WORKING PAPER 6
FAA PROJECT COORDINATION

MAY 2023
VERSION 1.0
DRAFT

Prepared by RS&H for the
Chisholm Hibbing Airport Authority

6.1 FAA PLANNING REVIEW AND COORDINATION

FIGURE 6-1
BASELINE CONDITIONS OF RUNWAY 13 ROFA PENETRATION

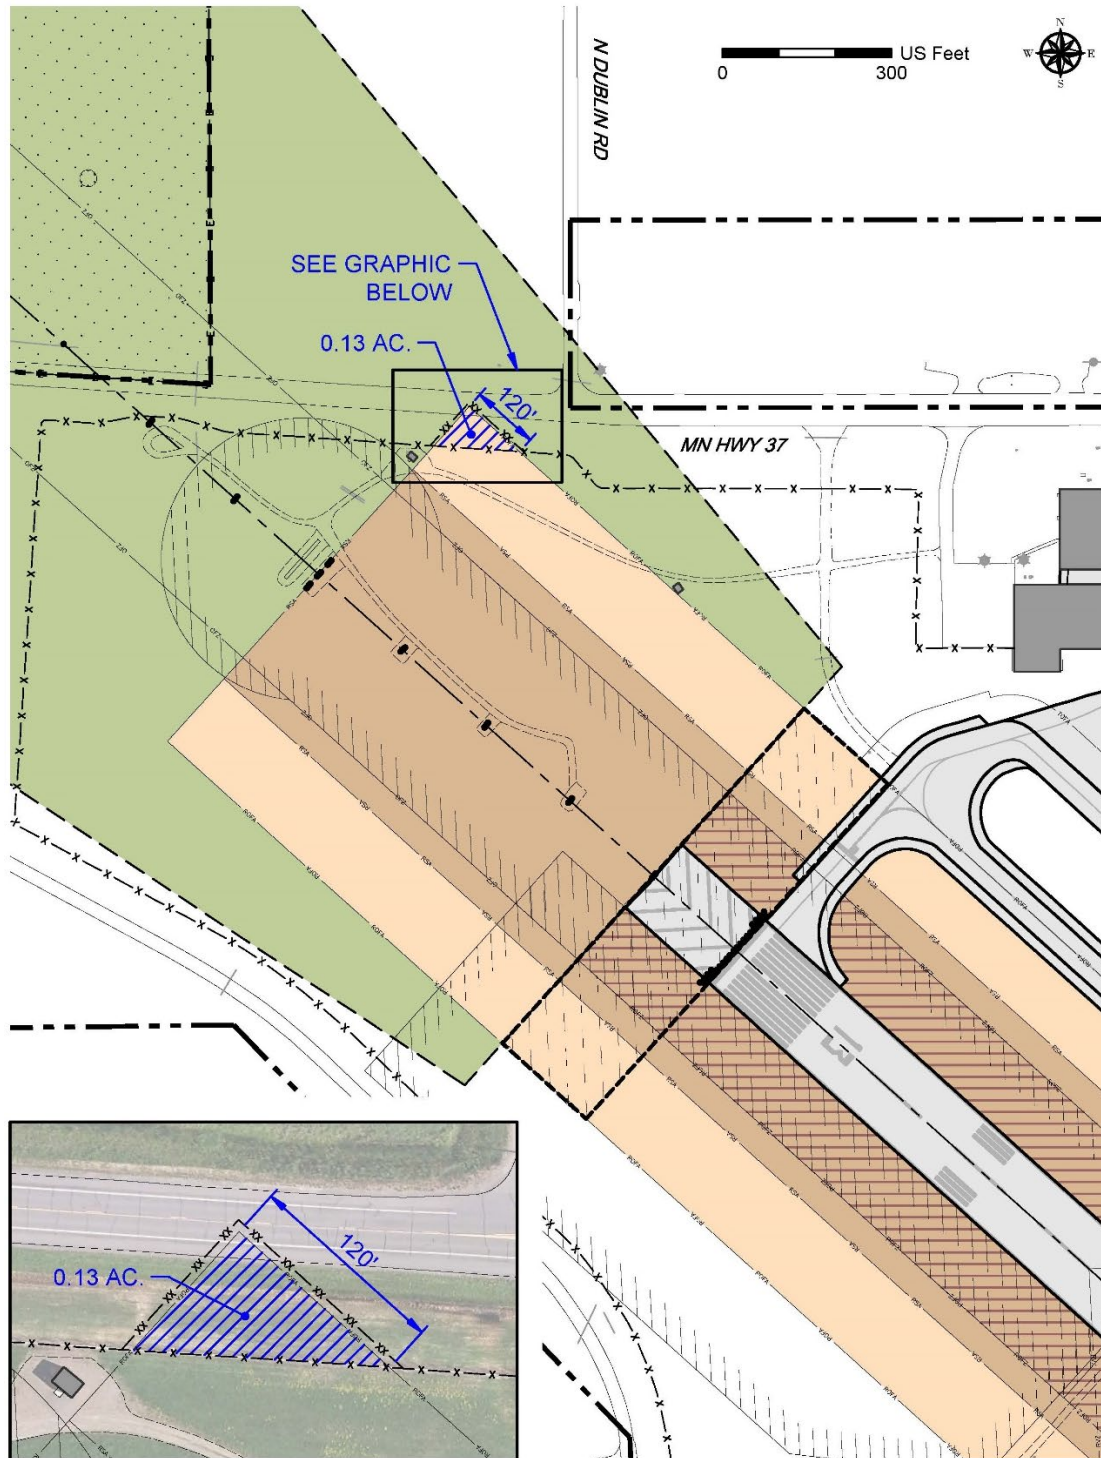
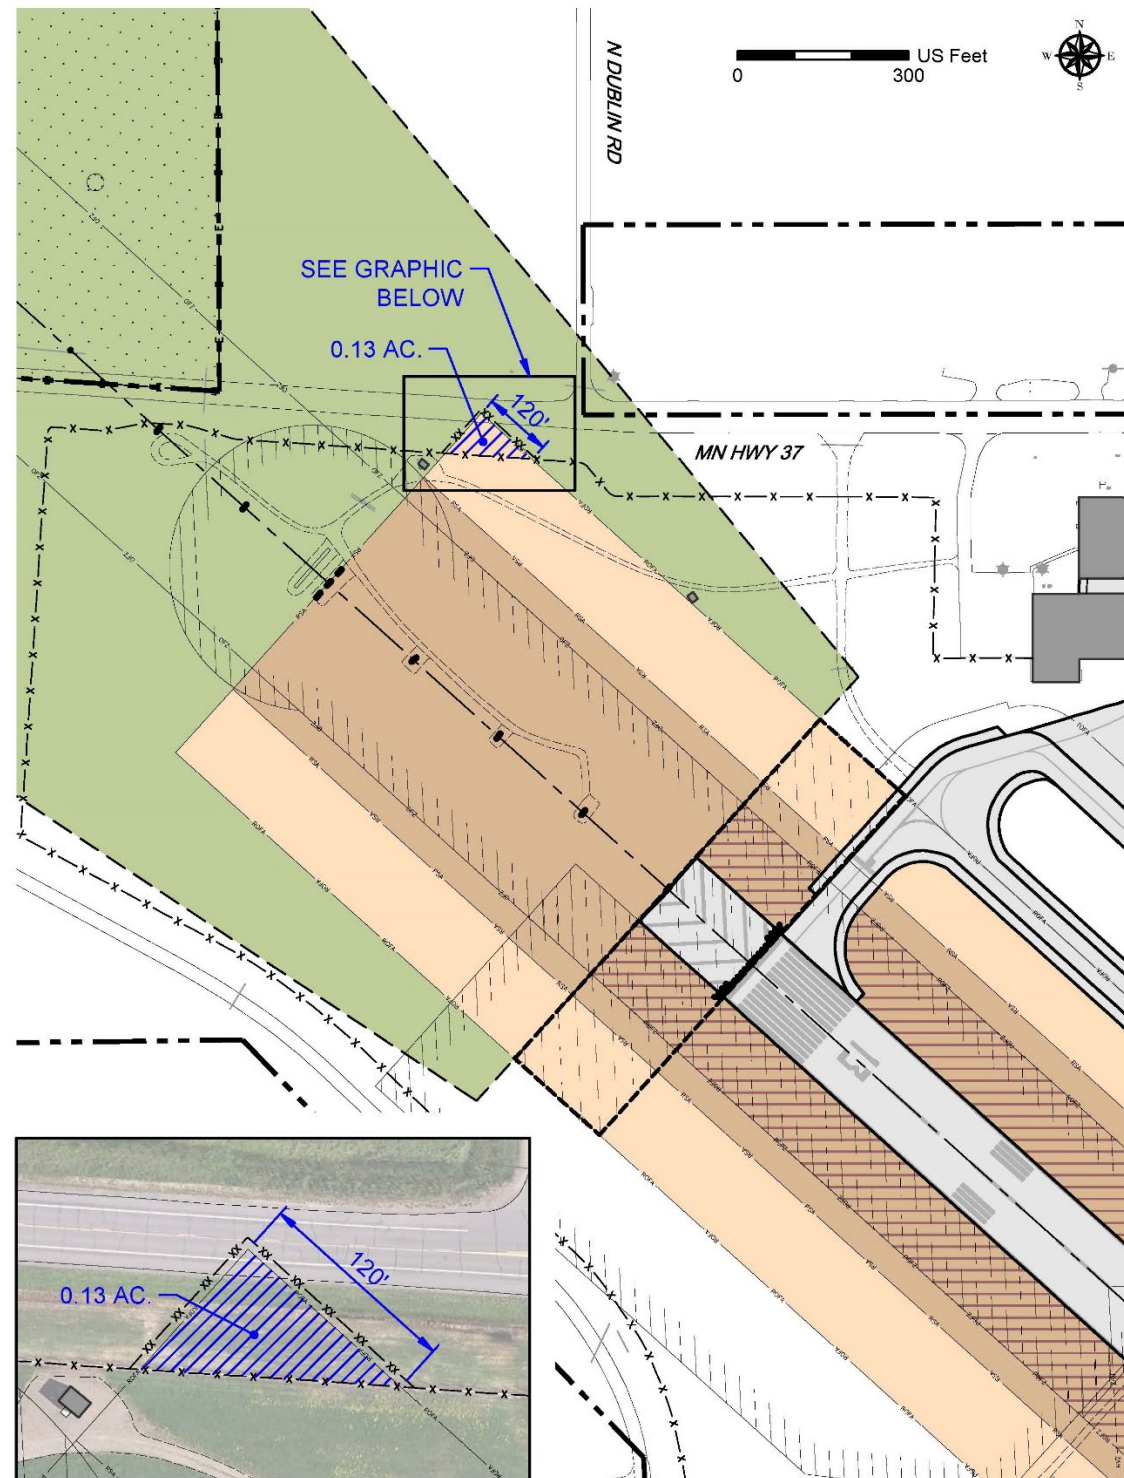
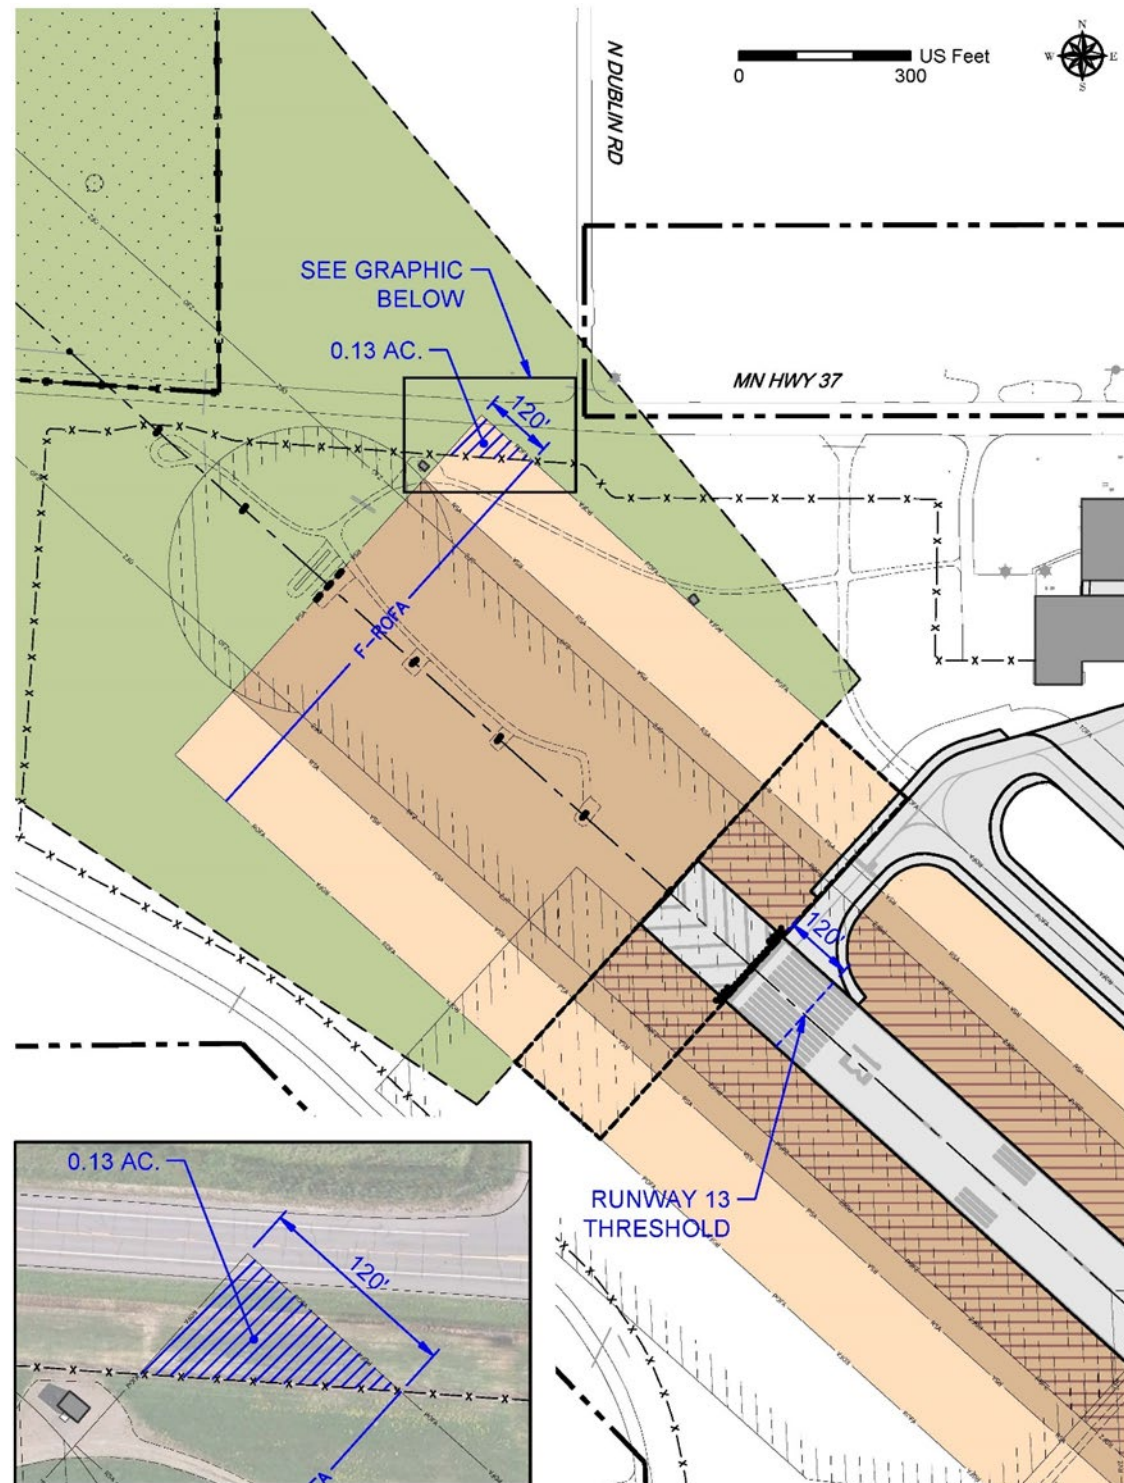
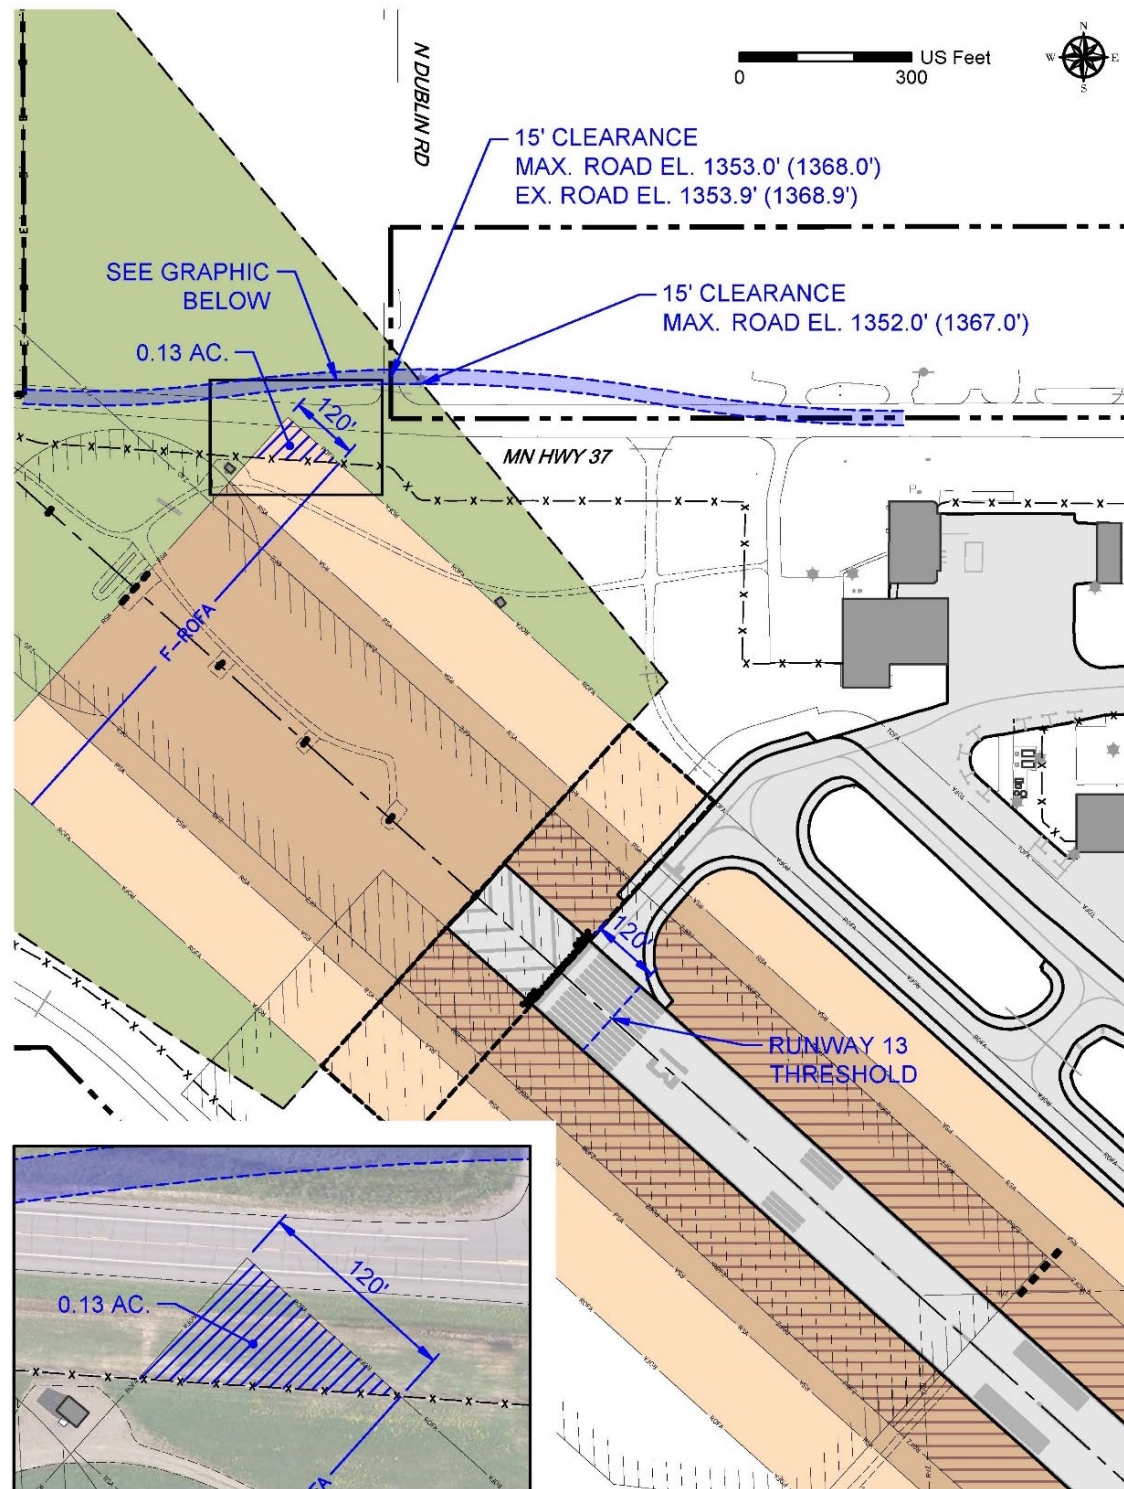
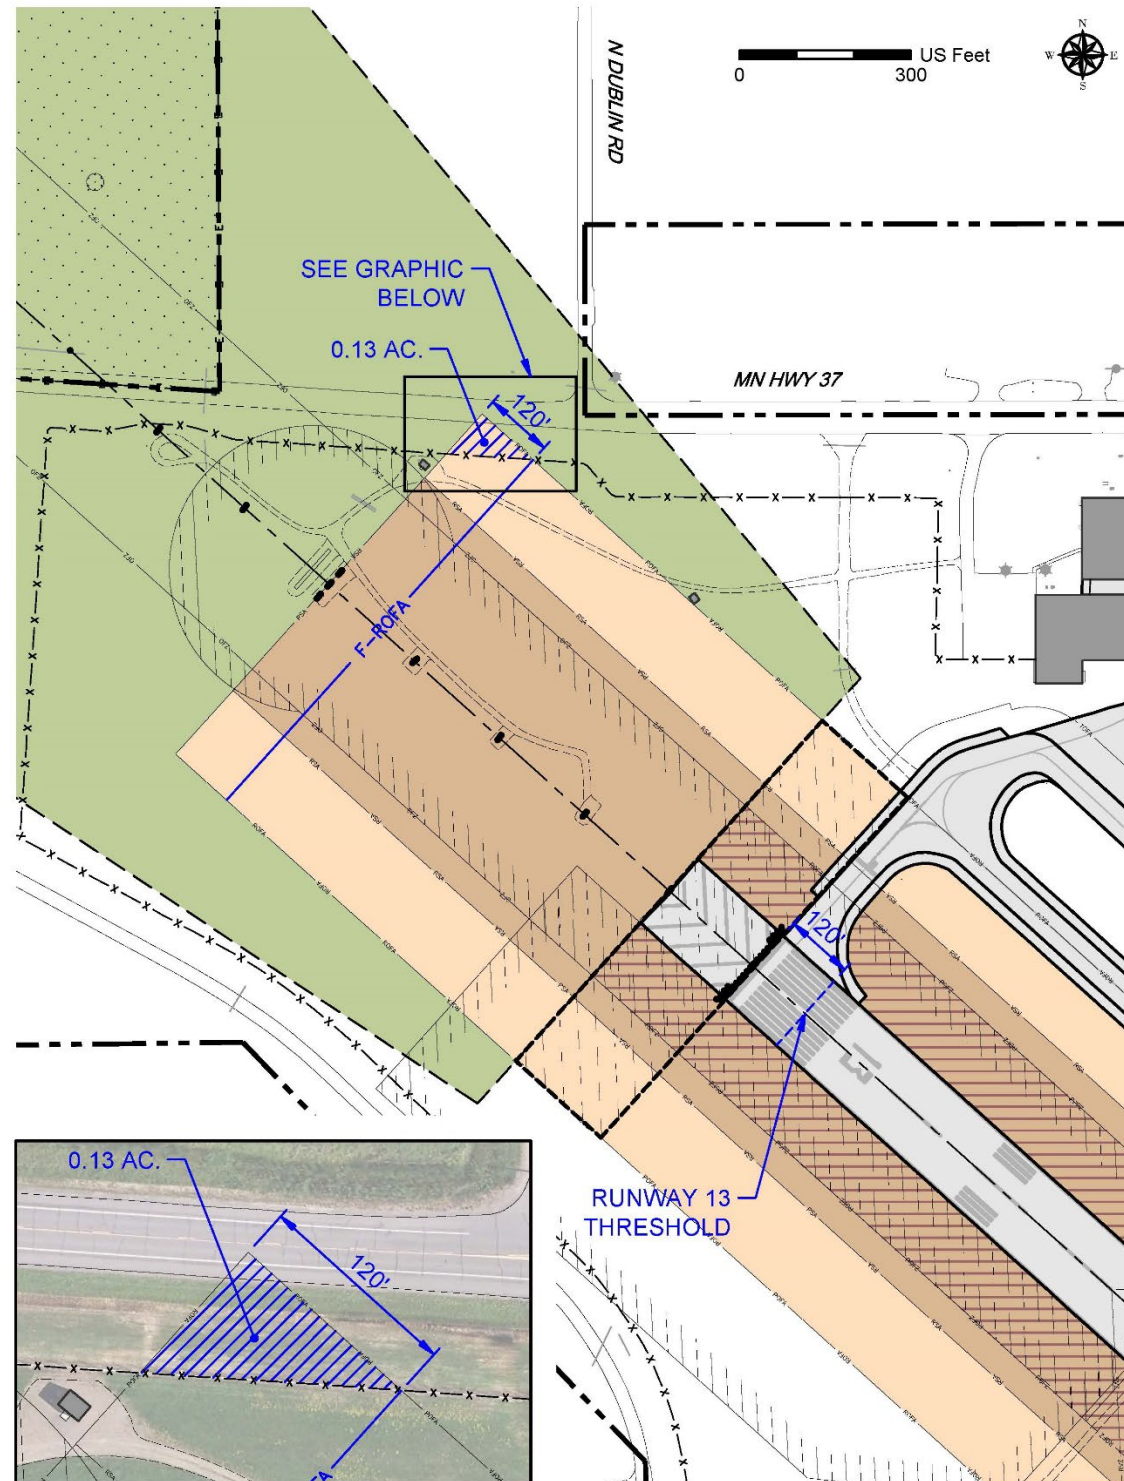
Due to many factors beyond the control of the master plan project team, most resulting from challenges faced across all industries during the Covid-19 global pandemic, timely FAA review of analysis was not achieved consistently during the project. As an important stakeholder in the planning process, FAA review of alternatives and implementation planning is highly beneficial when it takes place at specific milestones (i.e., forecast, facility requirements, alternatives, and implementation) throughout the entirety of the master planning process. Full review of alternatives and implementation analysis was considerably delayed during the pandemic and did not occur until the end stages of the study. This review identified a few areas where more information and/or analysis was requested to support FAA AIP funding plans. All FAA-identified elements noted in the review were addressed (as applicable) in final master plan documentation ahead of this section. The following sections include three key areas where more thorough analysis was requested beyond what was previously scoped and performed within the master plan:

- » Expansion of alternatives to address Runway 13-31 ROFA impacts
- » Expansion of alternatives to address/clarify 'Airfield Pavement Design and Construction Phase I' project purpose, need, and justification
- » Incorporation of apron tie-down configurations

Runway 13-31 meets C-III category aircraft design standards but has a 0.13-acre fraction of land in the northeast corner with state highway Mn-37 right-of-way and an airport security/wildlife fence within the Runway Object Free Area (ROFA). Per FAA AC 150-5300-13A, *Airport Design* (since updated near the completion of the master plan study to -13B) the ROFA is clear area limited to equipment necessary for air and ground navigation, providing wingtip protection in the event of an aircraft excursion from the runway.

The additional analysis requested by the FAA to address the Runway 13-31 impacts included the following items detailed in the text below:

- » Supplemental runway length analysis
- » Additional alternatives analysis to address the ROFA deficiency

ROFA Alternative 1 (Modification of Standard) is an appropriate near-term solution, but ultimately does not address the primary safety concern. While the history at HIB shows the risk probability is very low for an accident/incident occurring within the 0.13 acres of non-standard ROFA, the preferred long-term solution should address the underlying non-standard condition. An MOS is the lowest cost solution

because it is purely administrative. For these reasons, the MOS is the preferred near-term solution but is recognized that a long-term solution must also be included in this plan. Establishing an MOS can act as a step toward resolving the issue when included as part of a larger preferred program.

ROFA Alternative 2 (Displaced threshold and physical runway shift) does address some long-standing nonstandard conditions by eliminating the nonstandard ROFA condition, and potentially some Part 77 obstructions at the north end of the runway, but it also creates new obstruction challenges at the south runway end. RPZ impacts at the Runway 13 approach end would remain with similar impacts to existing conditions. Pursuit of Alternative 2 would require a detailed advanced planning study and cost-benefit analysis to document the full breadth of impact to existing facilities and operations at HIB. This alternative would require, at a minimum, a NEPA environmental assessment study, relocation of navigational aids, and updated flight procedures. One noteworthy benefit is that a shift of up to 200 feet at the Runway 31 end would not require any additional land acquisition. Alternative 2 would likely require the most capital investment if ever pursued as the long-term solution. At this time, Alternative 2 is not the recommended long-term solution.

ROFA Alternative 3 (Mn-37 Realignment) addresses long-standing nonstandard conditions by realigning Mn-37. Realigning the roadway requires coordination with MnDOT and is a practical long-term solution. Preliminary roadway engineering analysis of curve tangents, superelevation, and runoff requirements prove the project is feasible. Planning level rough order of magnitude cost estimates show a realignment of Mn-37 is more financially practical than infrastructure changes to Runway 13-31 shown in Alternative 2. Like Alternative 2, a cost-benefit analysis should be performed. The NEPA environmental process and land acquisition would also be necessary. Analysis shows the road realignment could be achieved without impacting the neighboring cemetery. One additional benefit of realigning the road is that it can also address existing Part 77 obstructions created by the road.

ROFA Alternative 4 establishes a displaced threshold for Runway 13 to allow the ROFA to meet FAA design standards. Displacing the Runway 13 threshold reduces usable landing distance (LDA) which is not a feasible solution to support aircraft performance needs, especially when considering the runway requirements analysis in **Appendix B, Aircraft Performance and Instrument Procedure Considerations** which demonstrate the need for a longer runway to support existing operations that don't yet meet the 500 annual operations criteria for critical aircraft. Additionally, a displaced threshold does not address long-standing Part 77 obstructions created by Mn-37 which was expressed by both FAA and MnDOT as a desirable outcome. This alternative would also require FAA to review/update established instrument procedures as well as require a degree of pilot diligence that erodes standard safe airfield conditions. Alternative 4 is not the preferred solution to address the non-standard ROFA.

Alternative 3 is the preferred long-term solution at this time when combined with the near-term Alternative 1 (MOS) solution. FAA expressed that an MOS was a feasible near-term solution and could be pursued when Runway 13-31 rehabilitation was needed. At that time, additionally advanced planning to focus on implementing the roadway solution would be necessary.
